DAVID PLUMMER & ASSOCIATES

**Re: Mediterranean Village Review - #14153
Traffic Impact Study, Parking Analysis & Valet Operations Analysis**

David Plummer and Associates (DPA) have completed several reviews of the Traffic Impact Analysis, Shared Parking Analysis, Parking Garage, and Valet Operation Analysis conducted for the proposed Mediterranean Village project. A summary of these components is below.

HOTEL DROP-OFF - OPTION #1 "ORIGINAL SUBMISSION"

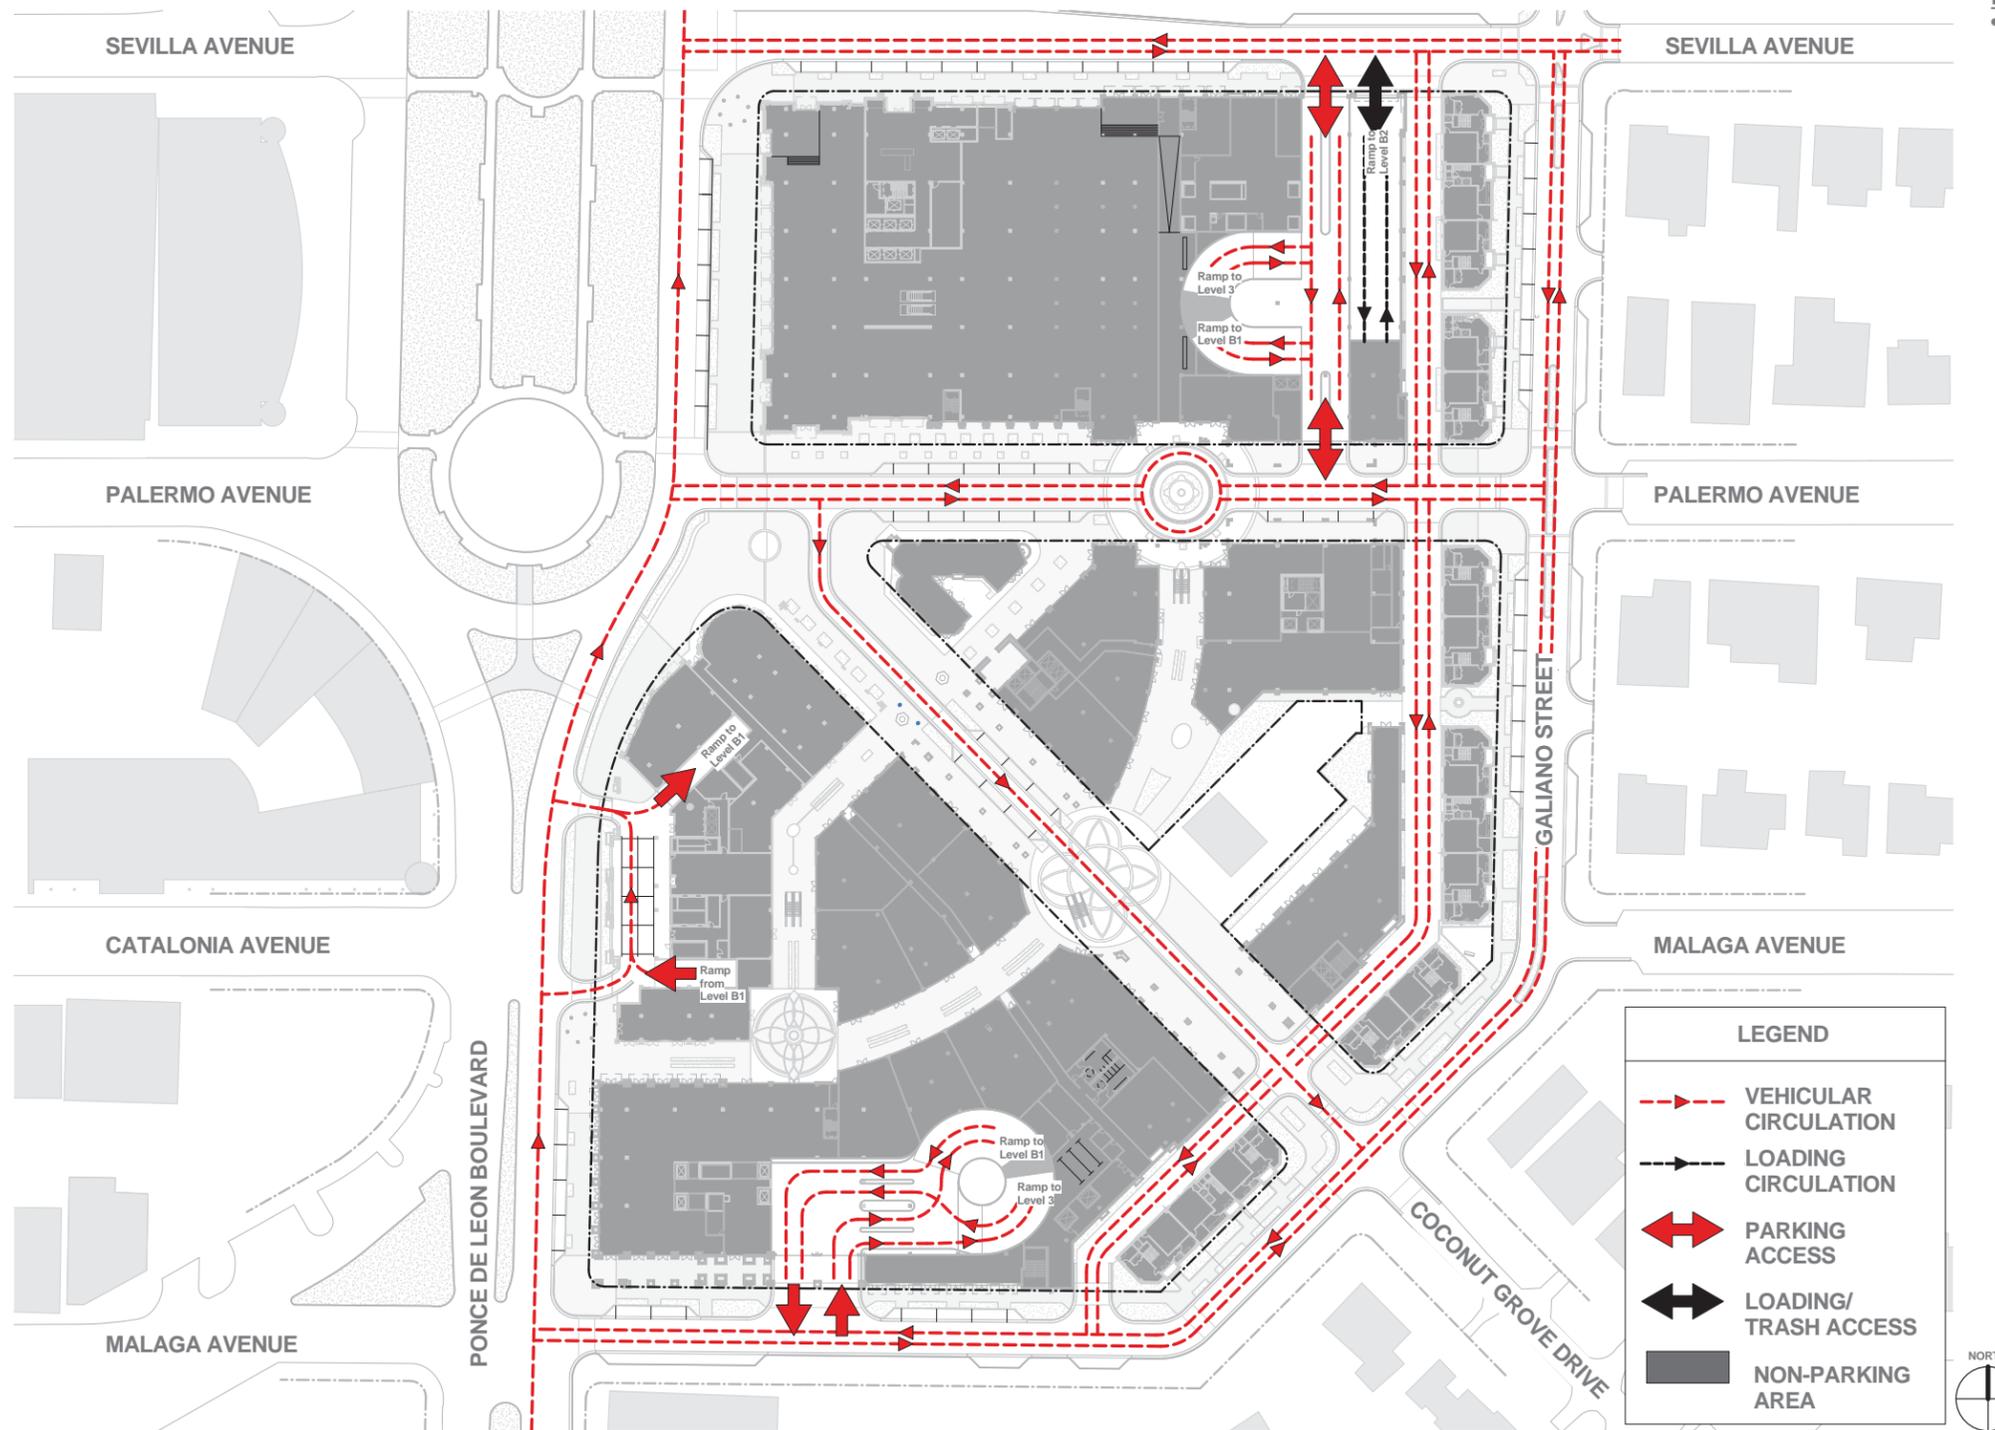
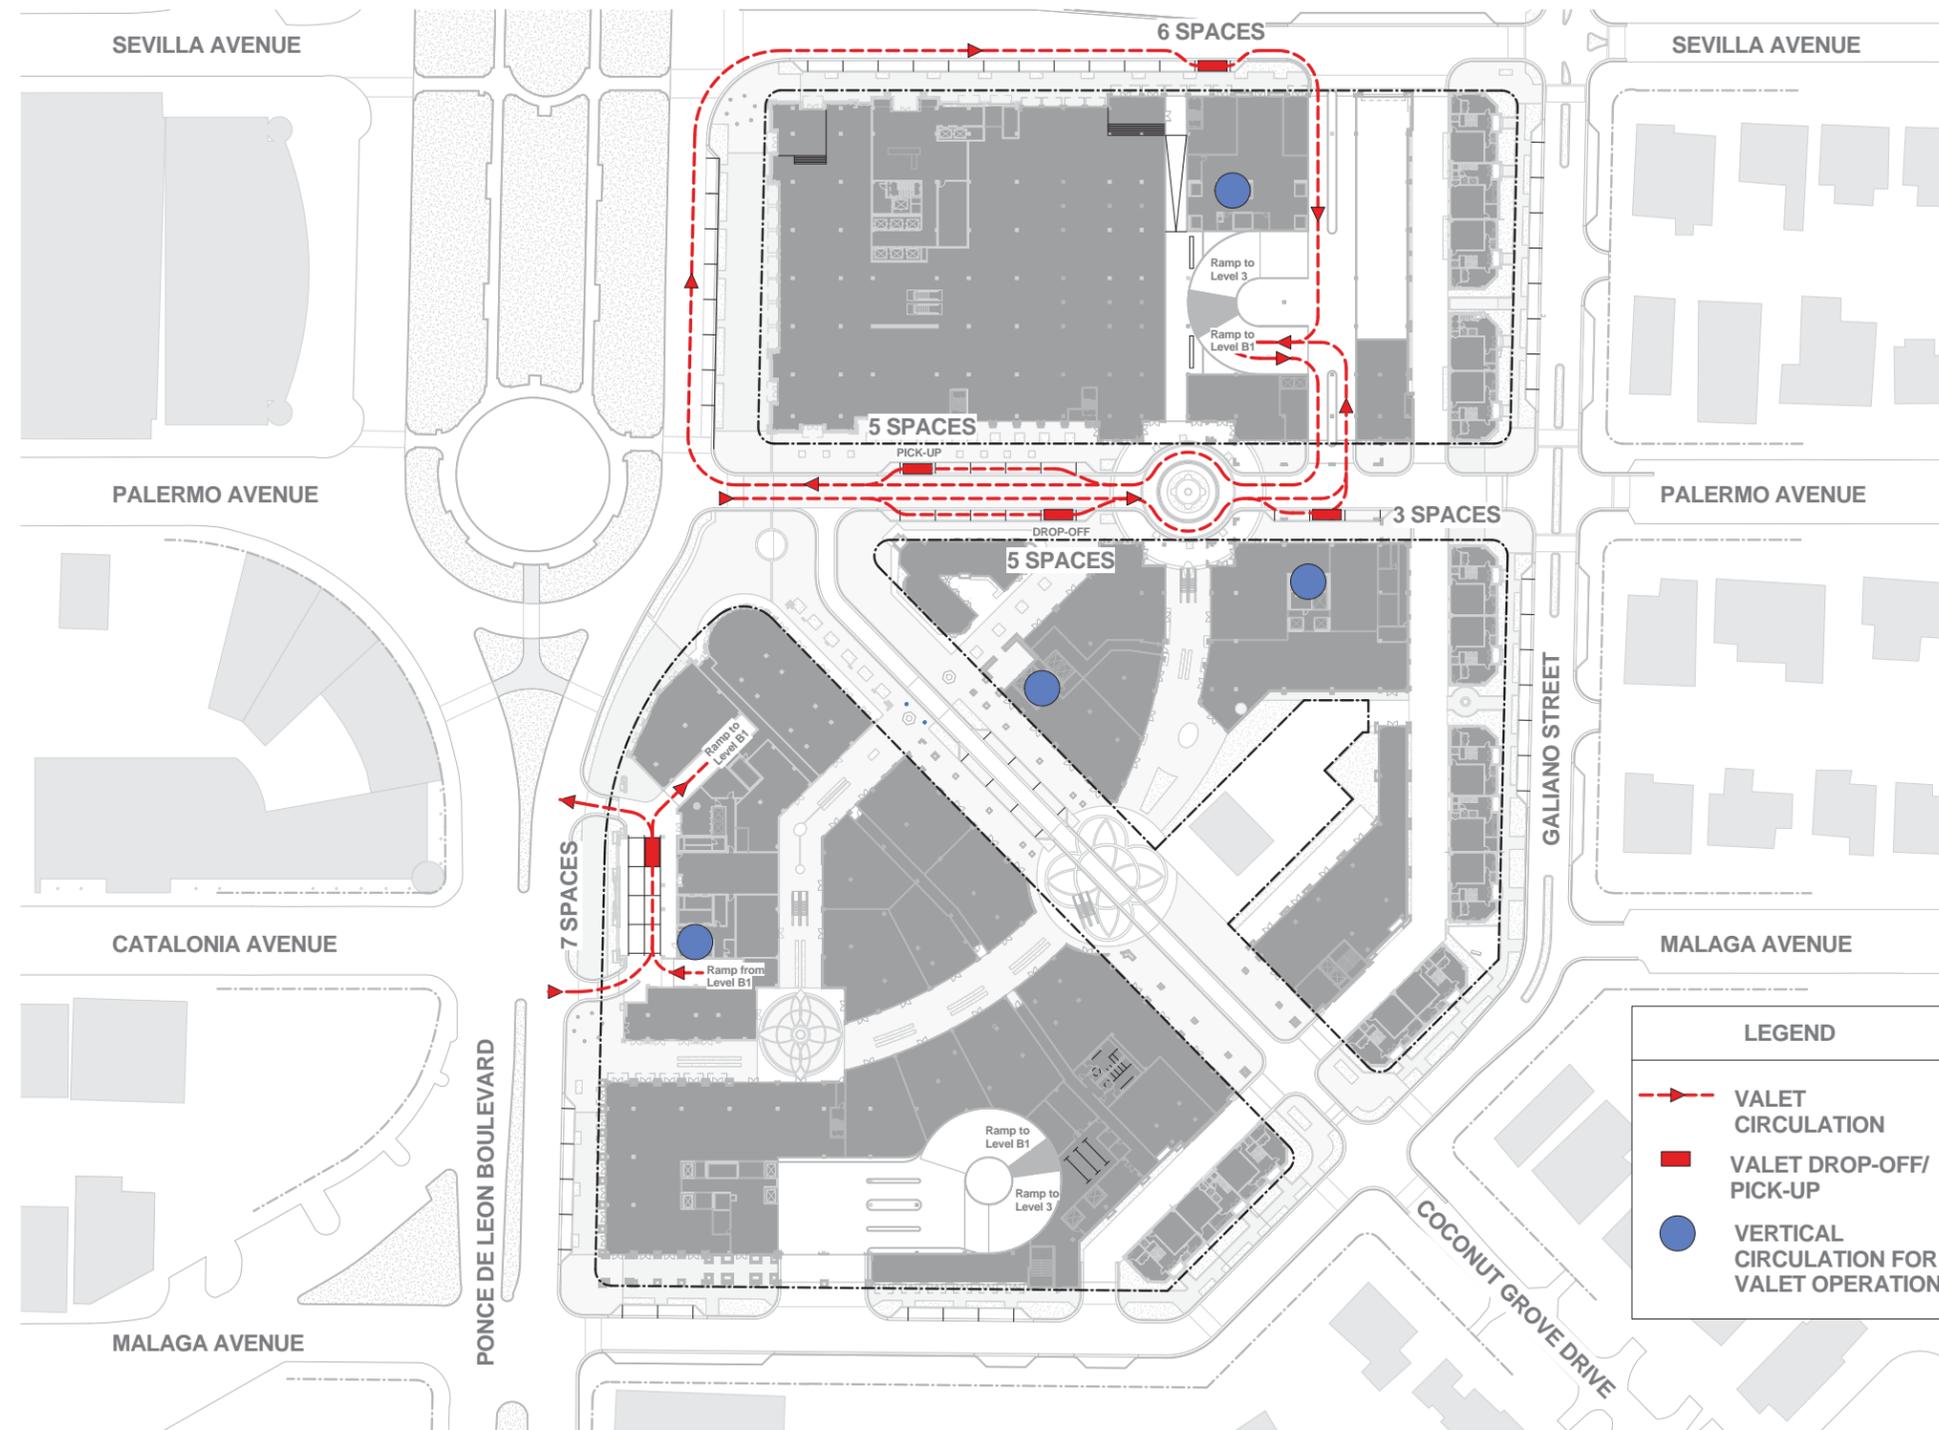
During first reading, the project included direct access to the hotel from Ponce. This access plan for the hotel was acceptable. The project has since changed to address comments from the Commission. Of the newly proposed options, Option 3 is an acceptable alternative and preferable to Option 2 provided that the following conditions are included: 1) the hotel valet ramps will be completely segregated from the Malaga driveway ramping system and no traffic from Malaga would be allowed to access the hotel's porte cochere, and 2) two one-way ramps (similar to the Ponce alternative) or a two-way, two-lane ramp for hotel valet use only is provided. See attachments for hotel access options.
